<b>Notice of Allowability</b>	<b>Application No.</b>	<b>Applicant(s)</b>	
	10/646,044	CHEMELEWSKI, DAVID	
	<b>Examiner</b>	<b>Art Unit</b>	
	Benjamin C. Lee	2632

### EXAMINER'S AMENDMENT

FIG.1

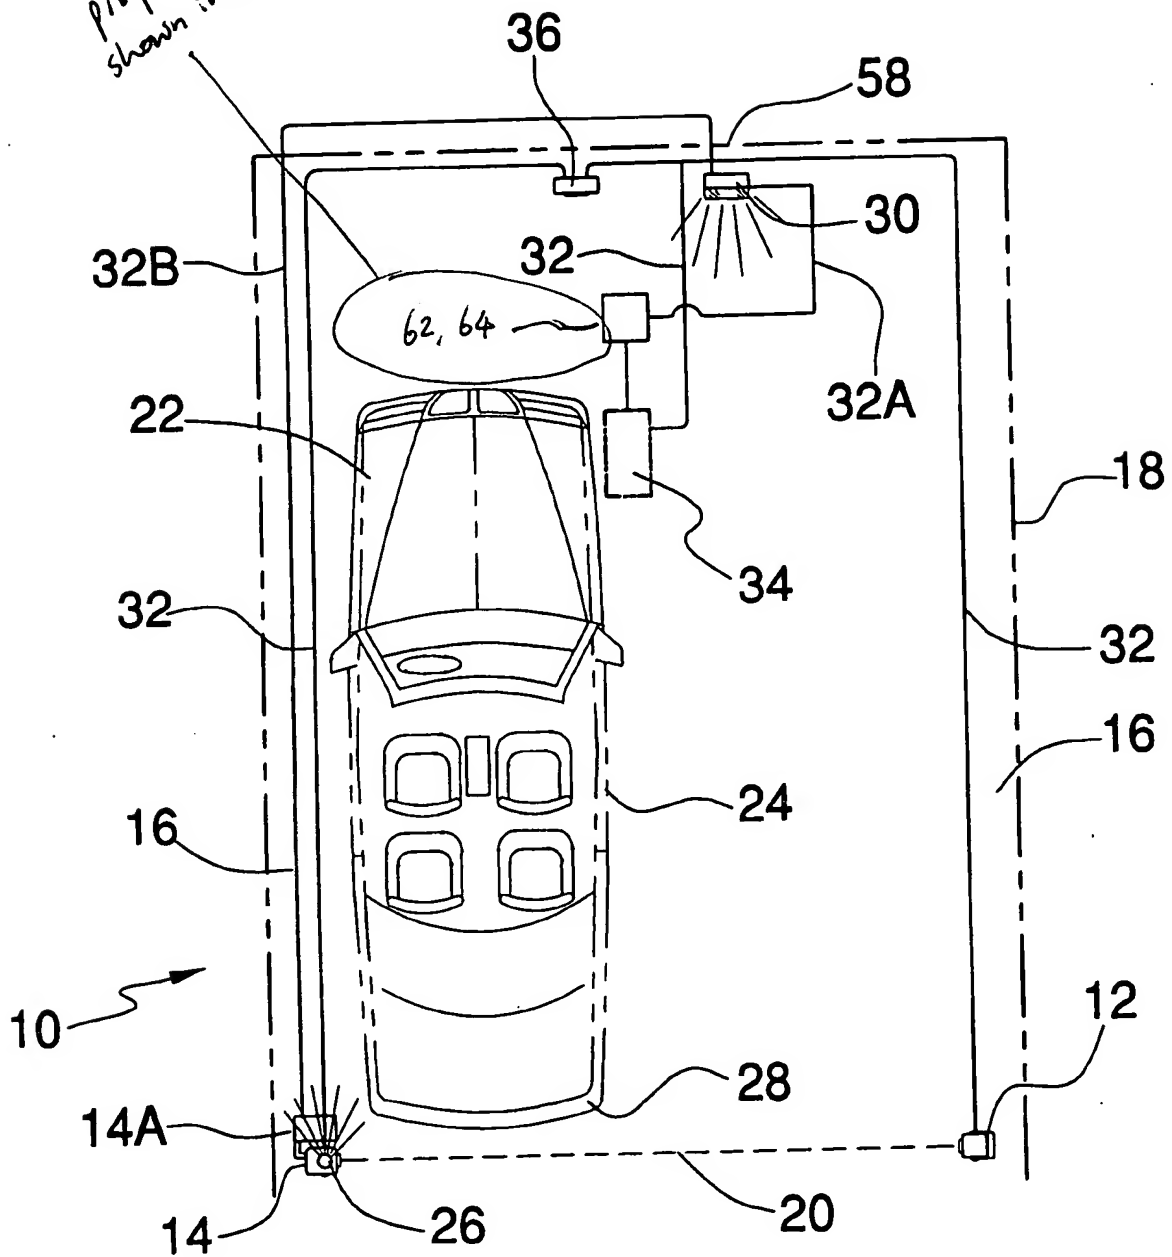
2. The following changes to the drawings have been approved by the examiner: 1) In Fig. 1, the labels "62" and "64" have been attached to the unlabeled box situated between 30 and 34; 2) In Fig. 3, label "36" has been changed to --30--. See Attachment. Note that **all drawings and changes** have to be based on the original figures filed 8/22/03 as opposed to Applicant's later filed drawings which looked different from the original figures and thus containing new matter (i.e. Figs. 1-2). Only new drawing sheets containing amended figures 1 and 3 need be submitted,

proposed changes  
shown inside circle

Proposed Fig. 3 approved by Examiner

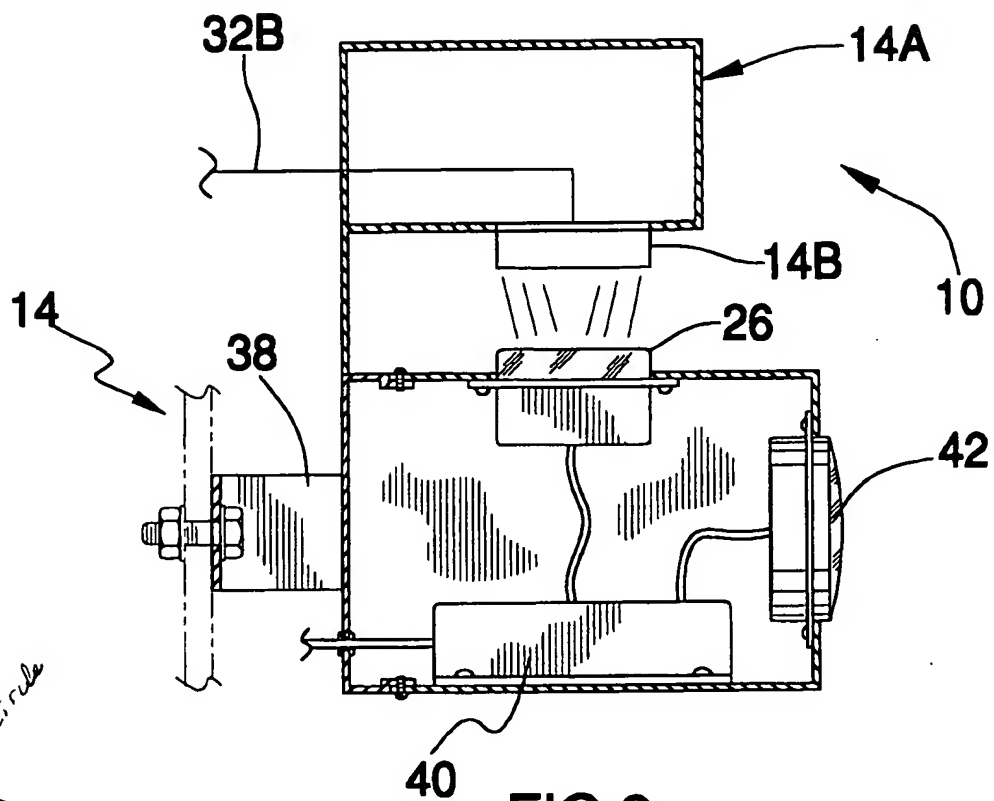
Proposed change  
shown inside circle

in which figure 2 contained on the same sheet with figure 3 should remain unaltered as was originally filed on 8/22/03. In order to avoid abandonment of the application, applicant must make these above agreed upon drawing changes.
